TO	Grace McDonald (ESR Australia & New Zealand), NSW Planning Manager	info@asongroup.com.au +61 2 9083 6601 Suite 17.02, Level 17, 1 Castlereagh Street, Sydney, NSW 2000 ABN: 81 168 423 872
FROM	Jae Jeon (Ason Group), Senior Traffic Engineer	
CC	Hamish Boots (ESR Australia & New Zealand), Senior Development Manager	
	Ali Rasouli (Ason Group), Principal Lead	
SUBJECT	3 Johnston Crescent, Horsley Logistics Park (HLP) Stage 2 – Response to Submissions (RtS) Technical Note

Ason Group has been commissioned by ESR Australia & New Zealand to prepare a Transport and Accessibility Impact Assessment (TAIA) to accompany the State Significant Development Application (SSD-71144719) for the proposed warehouse and distribution centre located at 3 Johnston Crescent, Horsley Park and referred to as Horsley Logistics Park (HLP) – Stage 2.

TABLE 1: ASON GROUP RESPONSE TO DPHI COMMENTS

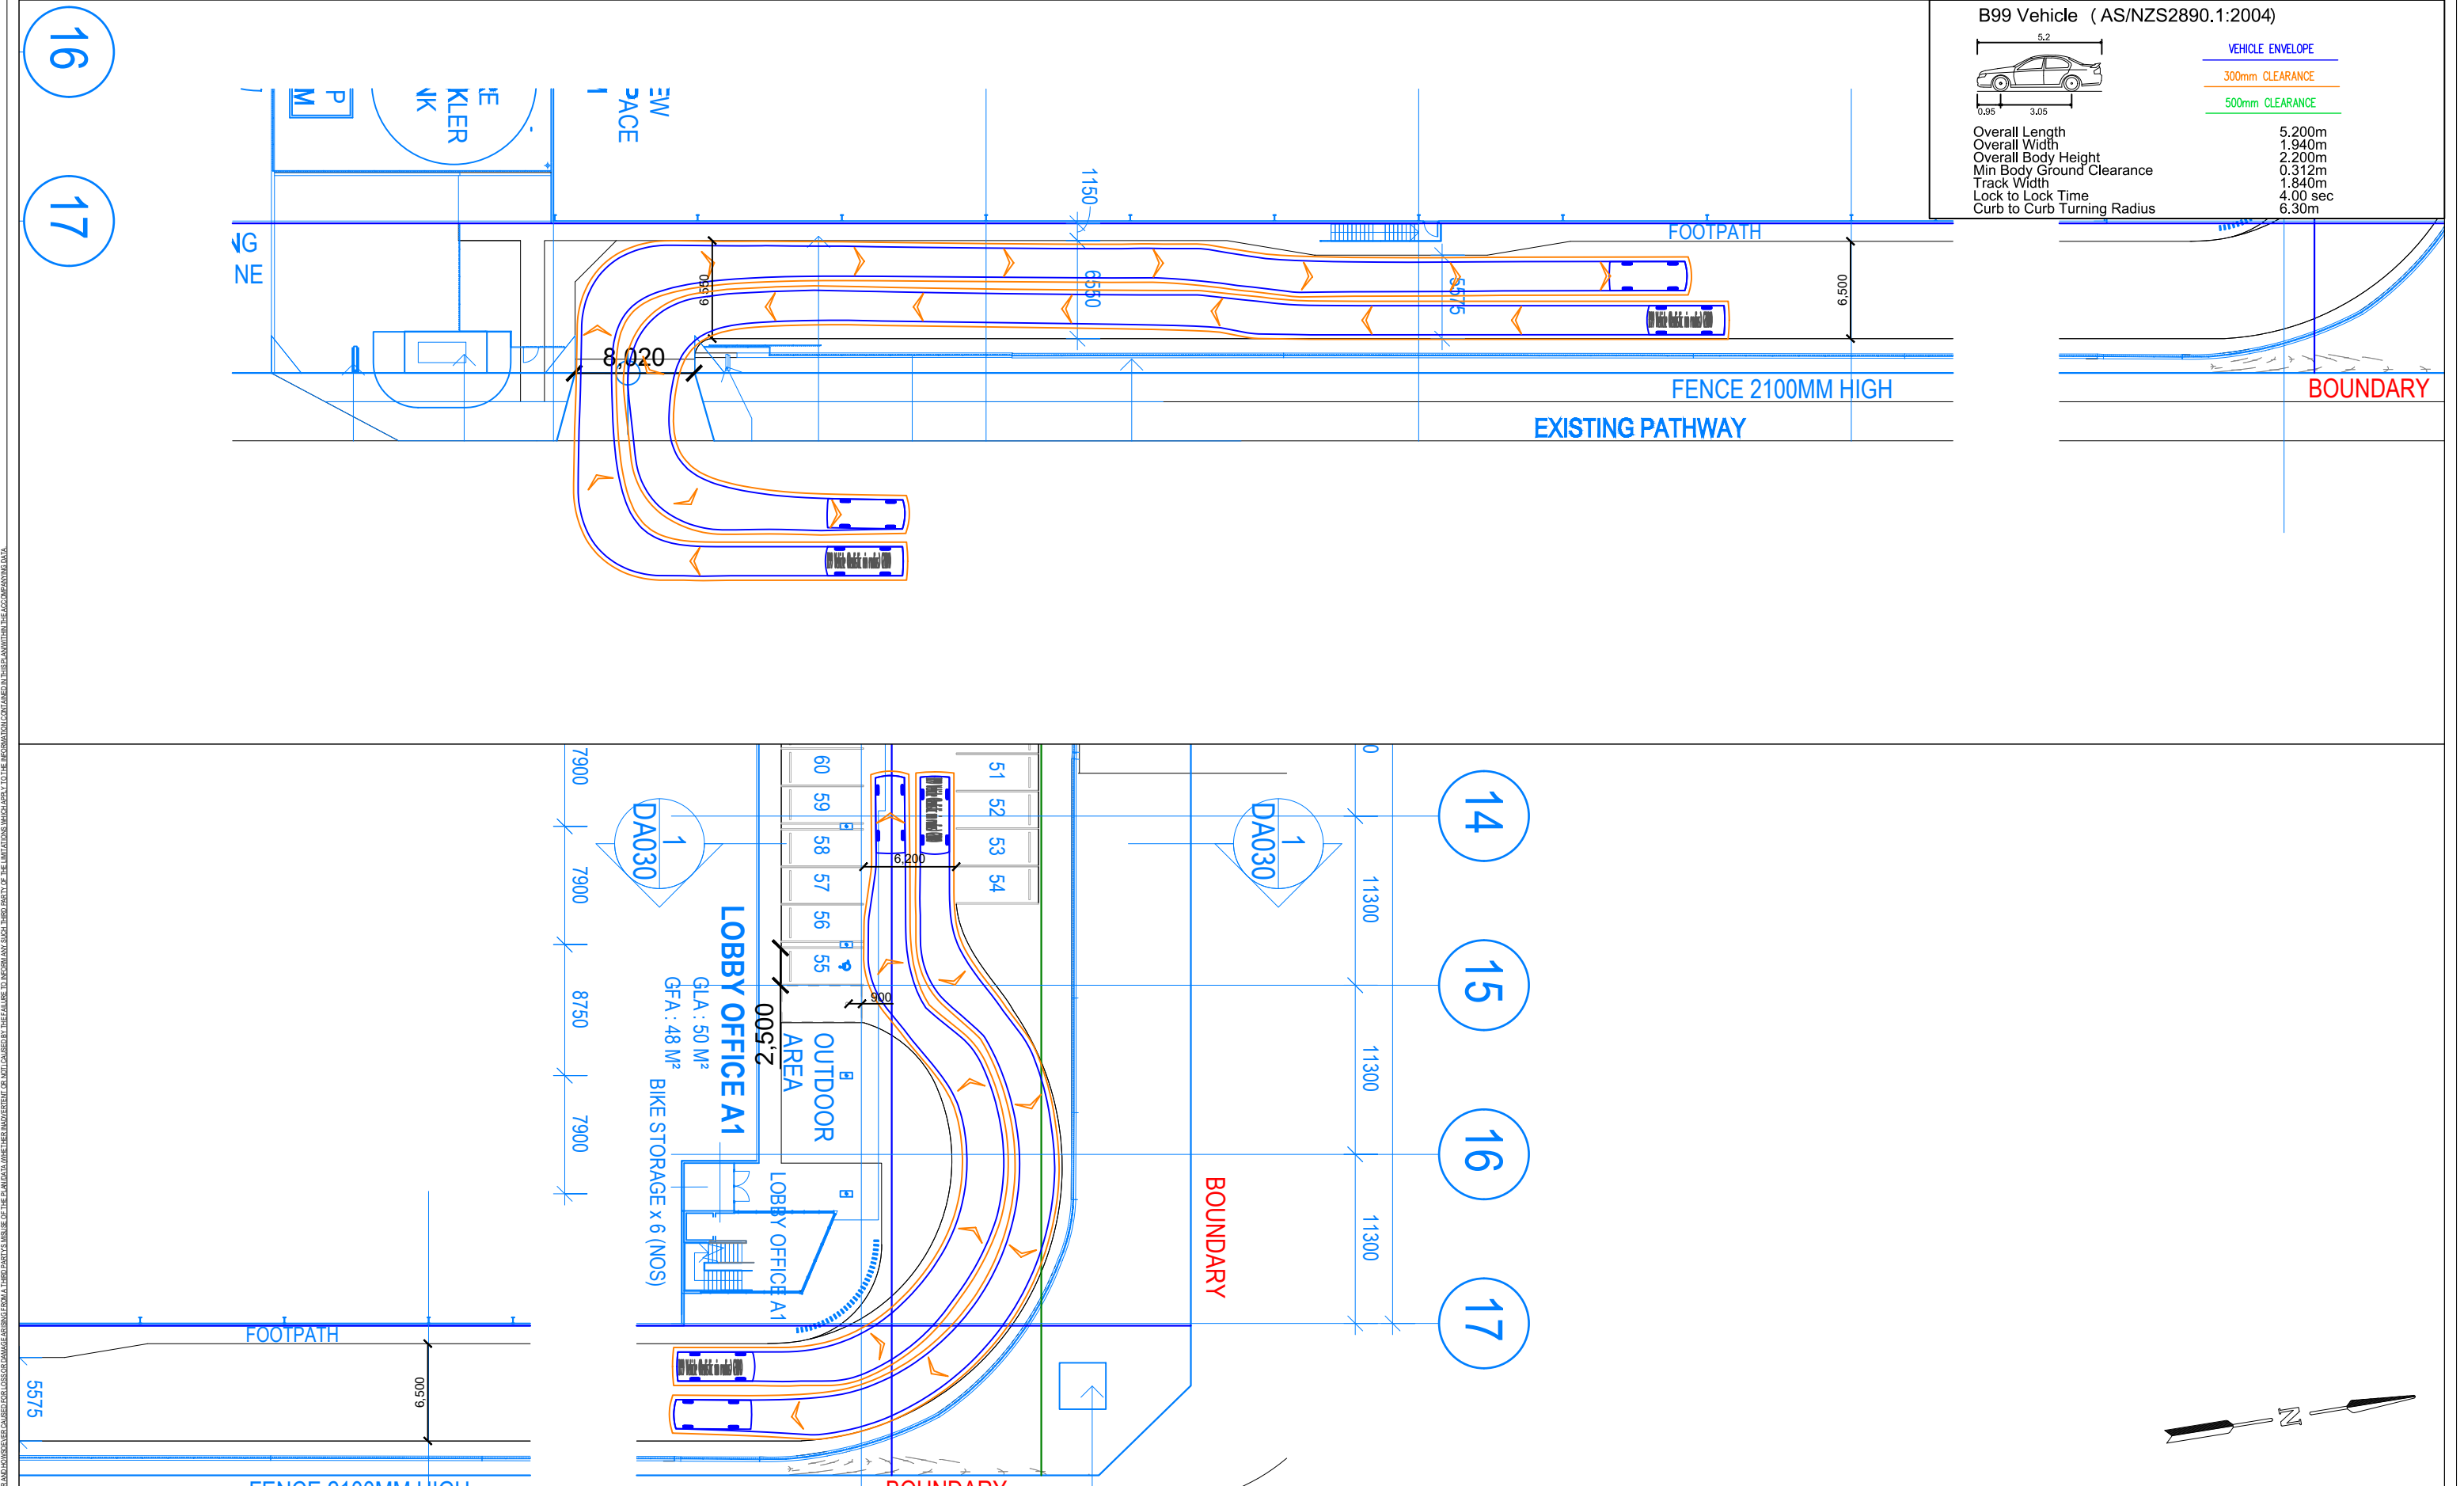
<p>vi. Swept path assessment of all anticipated vehicles and their movement (listed below) shall be provided to inform the car park design and layout to ensure adequate circulation aisle width is available for vehicles to manoeuvre safely within the site without any conflict (vehicular or pedestrian).</p> <ul style="list-style-type: none"> - B99 and B85 vehicles entering and exiting the driveway simultaneously. - B99 and B85 vehicles simultaneously passing the ramp. <p>B99 vehicles making a U-turn when all car parking spaces are occupied.</p>	<p>Swept path assessment has been undertaken for the additional scenarios requested and is provided in Appendix A. The assessment indicates that the proposed design can accommodate simultaneous movements of B85 and B99 design vehicles at the access driveways and ramps.</p> <p>Reference is made to AS2890.1:2004 and more specifically Section 2.4.2 (c) which stipulates that for blind aisles greater than the width of six 90-degree spaces, provision is to be made for vehicles to turn around at the end and drive out forwards. The proposed design has provisioned for 2.6m wide turning bays at the end of the blind aisles at both car parking areas therefore is considered to meet the design requirements. The locations and dimensions of the proposed turning bays are shown below.</p>
